CASE # C15-2010-D144
ROW # 10513121
TP-0111041012

CITY OF AUSTIN
APPLICATION TO BOARD OF ADJUSTMENT
GENERAL VARIANCE/PARKING VARIANCE

STREET ADDRESS: 1408 Hartford Road

A detached carport within the front yard setback.

1 SITE PLAN

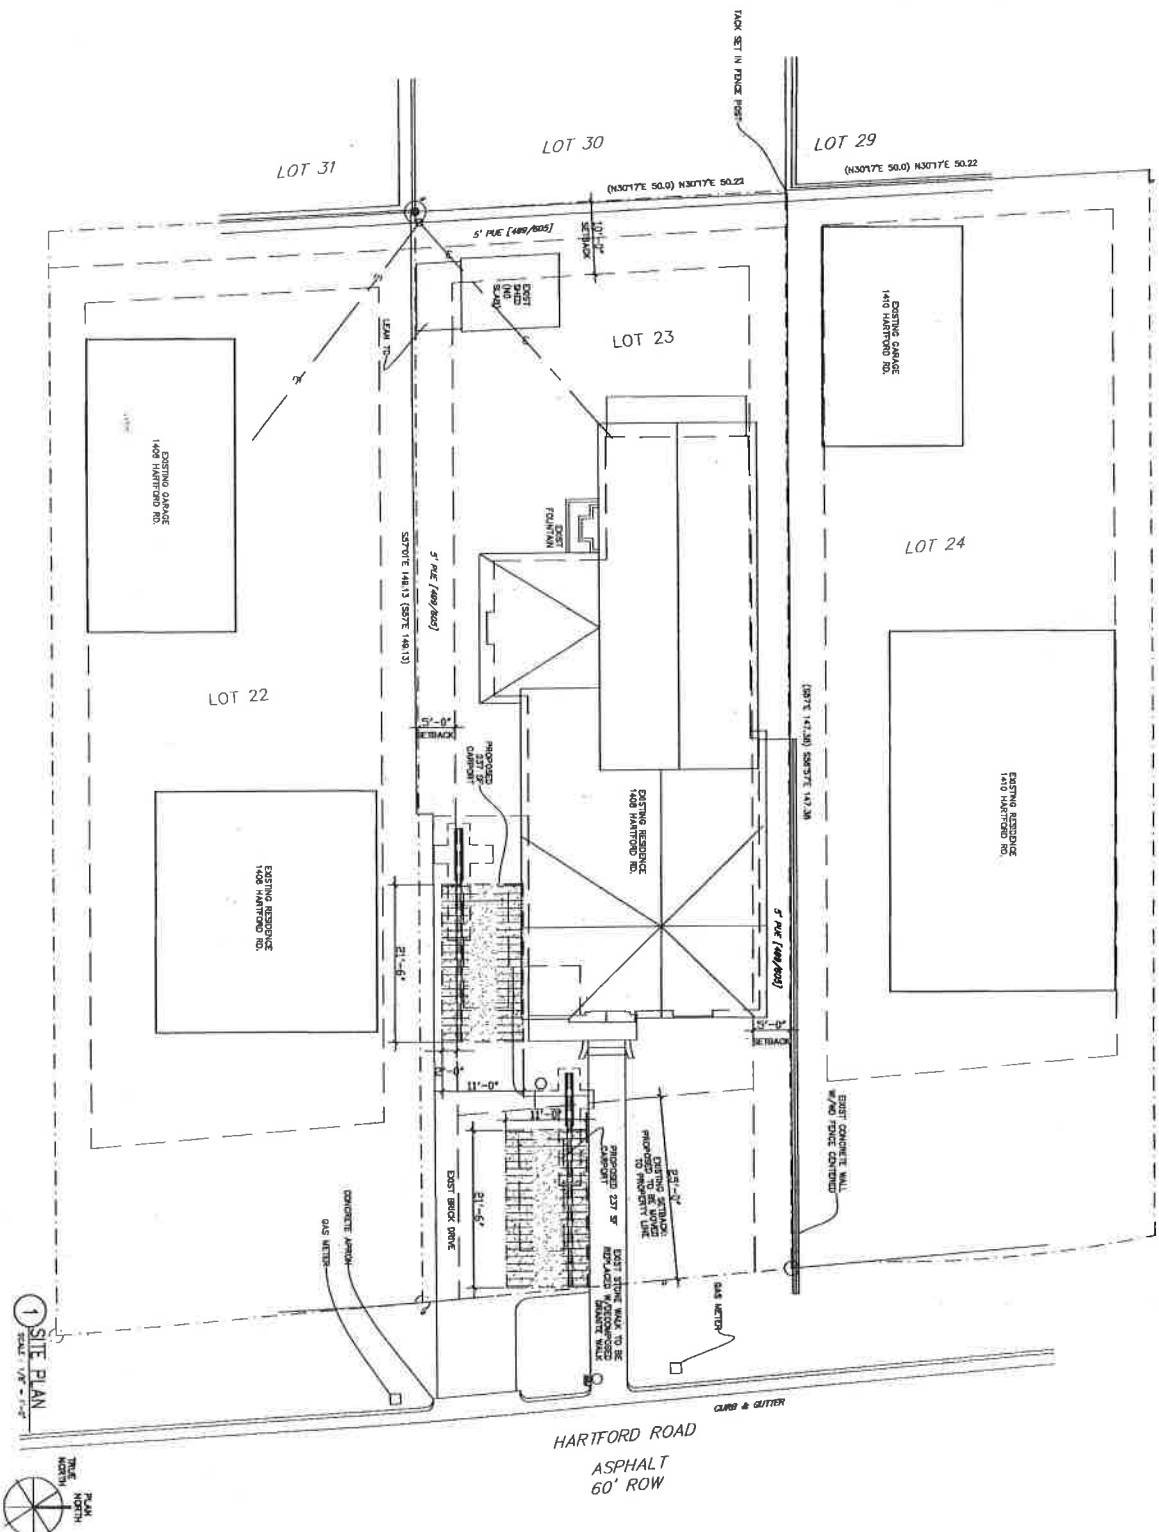
Cannot be located
in easement.

no overhangs
→ allowed
in easement
or must
have
license
agreement

1 SITE PLAN
SHEET 1 OF 1

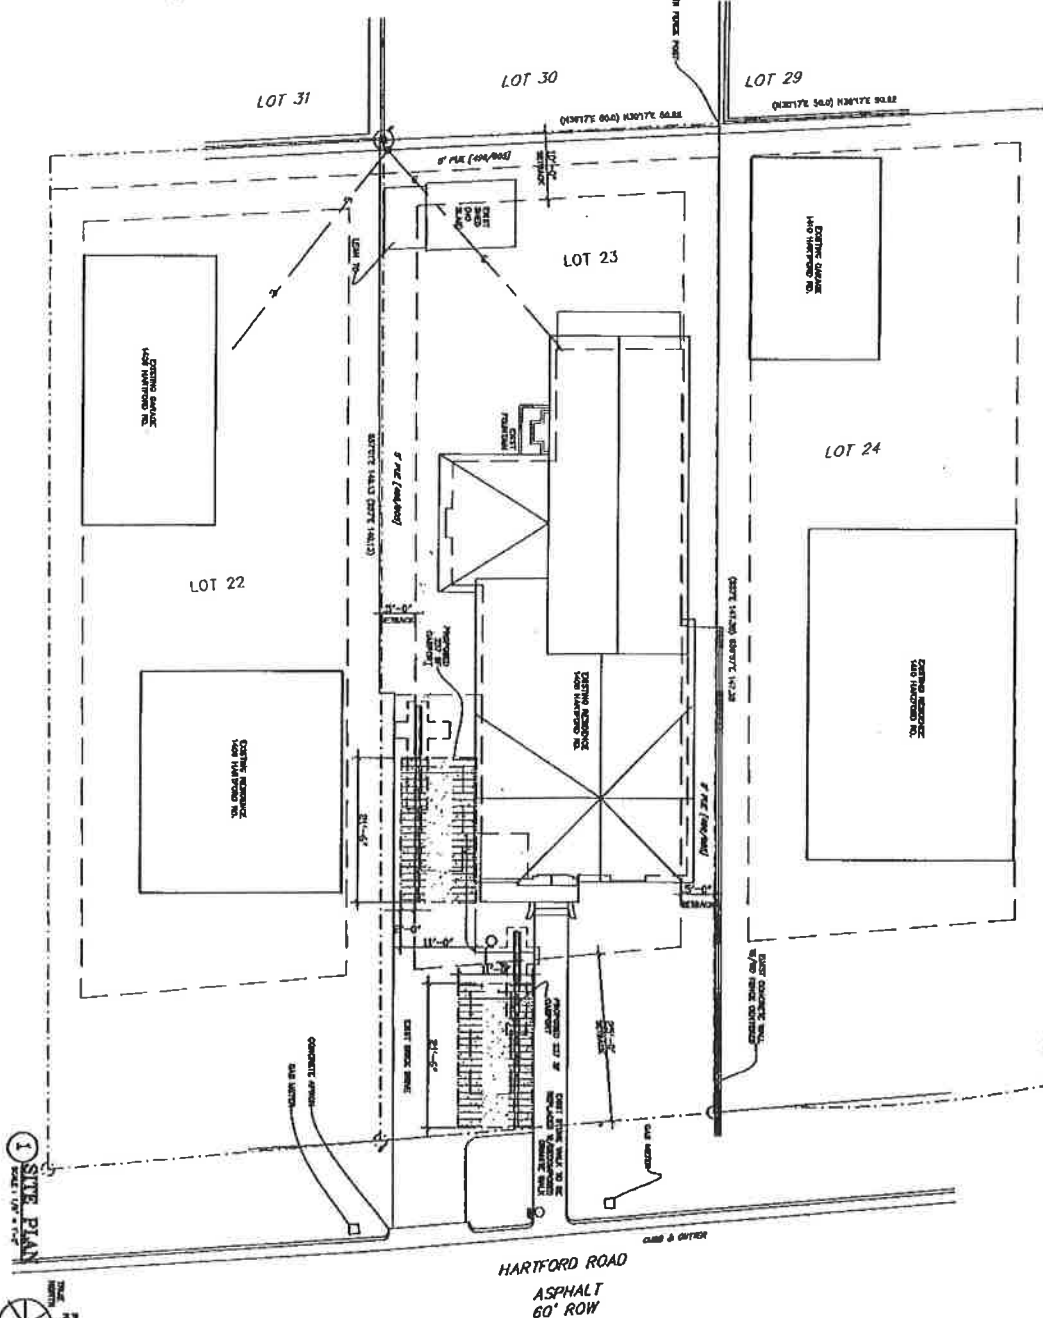
Austin Energy has reviewed this plan for 1408 Hartford Road
and approved the variance requested before the Board of Adjustment. Any changes to
this plan must be approved by Austin Energy.
